DCN No. E010166-00-C

DOCUMENT CHANGE NOTICE (DCN)

DOCUMENT No. (DOC-REV-GP.ID)	TITLE	NEW REV.
D980352-B-C	PMC Servo Rev C Attachment: Cut & Jumper Description (pp. 1-3)	С

CUT & JUMPER DESCRIPTION

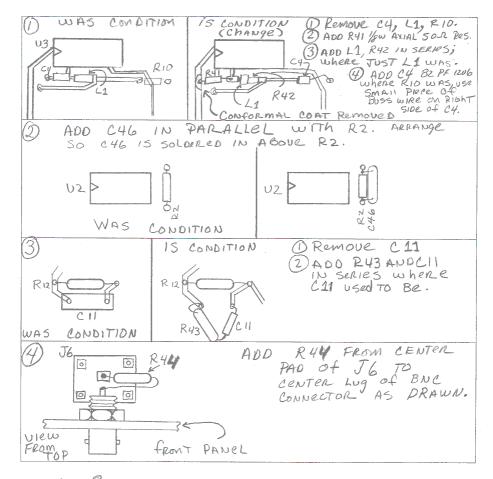
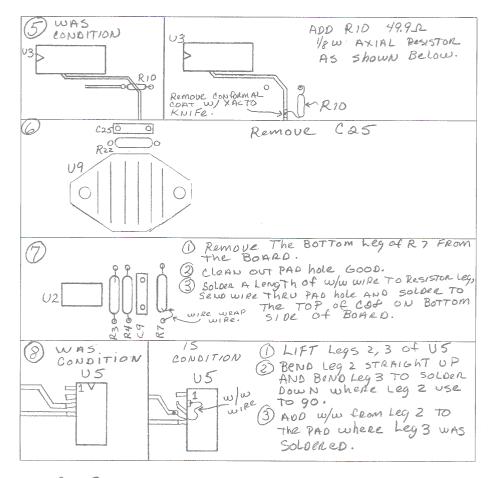
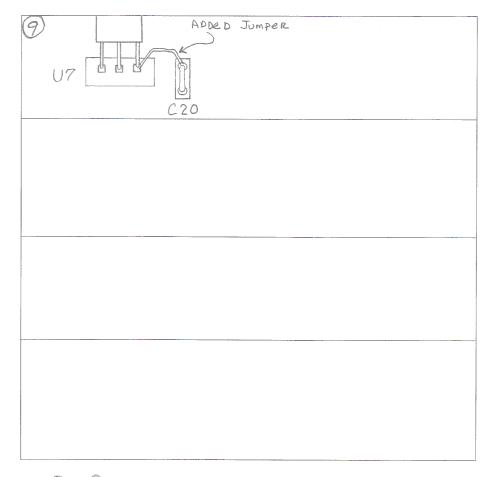
- 1. R41, R42, L1, C4 form a revised demodulation filter replacing C4, L1, R10
- 2. C46 (5 pF) has been added across R2
- 3. R43 (330 Ω), C11 (1 uF) form a revised lag network around U6. C12 (.047 uF) and external 200 Ω resistor at U15-14 have been eliminated.
- 4. The 64K external resistor @ U9-1 is now designated R44; Its value is 63.4K
- 5. R10 (49.9 Ω) has been added.
- 6. C25, C36, R34, R32 are no longer installed
- 7. Attached Cut/Jumper Description
- 8. Attached Cut/Jumper Description
- 9. Attached C/J Description
- 10. R11/R12 change from 7.96K/79.6K to 7.87K/78.7K 11. Ground U3-8 and U3-9.
- 12. Make the following jumper connections: J10-1 to P2-7C (BMxOut-) and J10-4 to P2-7A (BmxOut+); J10-2 to P2-8C (RActDr-) and J10-3 to P2-8A(RActDr+)

1.Reduced filter response sensitivity to component variation; 2. Neutralization of op-amp input parasitic; 3.Removal of capacitive loading on U5A and U6. Circuit simplification; 4. Part availability 5.Ground floating switch input. 6. Not needed 7. Device hook-up correction 8. Attached C/J-PCB error 9. Attached C/J – PCB error. 10. Availability 11. Noise consideration.
